RE: 48th Avenue (E-470 to Aerotropolis Parkway) Infrastructure Site Plan Response Letter

Submittal Package:		Preliminary Development Application		A = Accept Comment - Correct, Add to, or Clarify plans D = Dismiss Comment C = Clarify or Discuss and resolve prior to next design phase R = Resolve comment in next design phase			48th Avenue (E-470 to Aerotropolis Parkway)		
Package Description:		ISP (site plans, landscaping plans), drainage report, photometrics							
		Reviewer:	Development Review Team	Agency:	City of Aurora		Date:	17-Mar-23	
Reviewer	Item Number	Drawing or Page	Comments	Initial Code	Response	Discipline	Final Disposition Code	Date	Verified (Initials)
Letter of Introduction									
dbickmir	59	1/2	The Sun Empire MP is approved. Contact the case manager for copy and review PIP to make sure access is coordinated.	A	Coordinated with Sun Empire MP. Will provide access at Little River and will continue coordination of a local 3/4 movement access pending construction timing.	Roadway	A	18-Jan-23	MJD

THE AURORA HIGHLANDS SUBDIVISION FILING NO. 25
A RESUBDIVISION OF A PORTION OF TRACT A AND B, THE AURORA HIGHLANDS SUBDIVISION FILING NO. 1, AND PORTIONS OF SECTIONS 16, 17, 19,

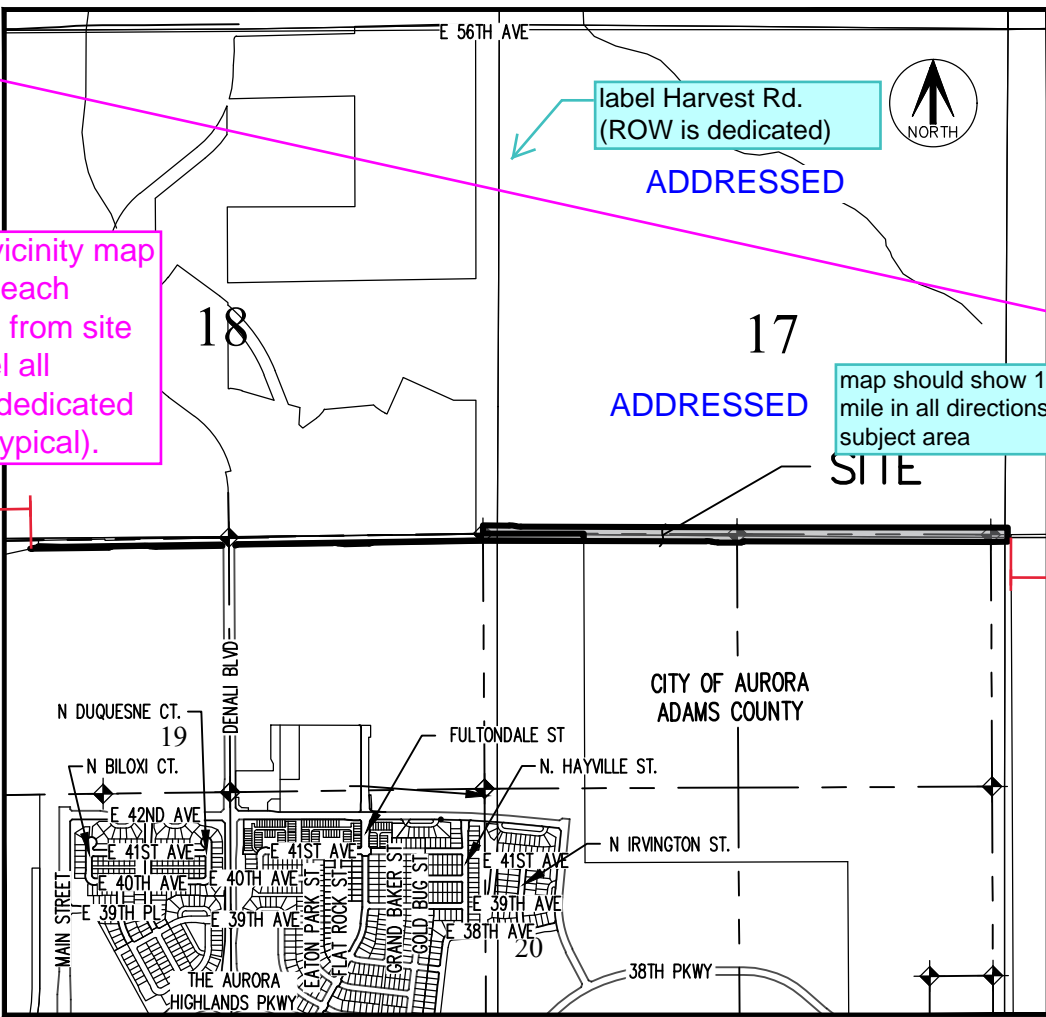
Extend vicinity map 1/2 mile each direction from site and label all publicly dedicated roads (Typical).

label Harvest Rd. (ROW is dedicated)

map should show 1/2 mile in all directions of the subject area

ADDRESSED

ADDRESSED
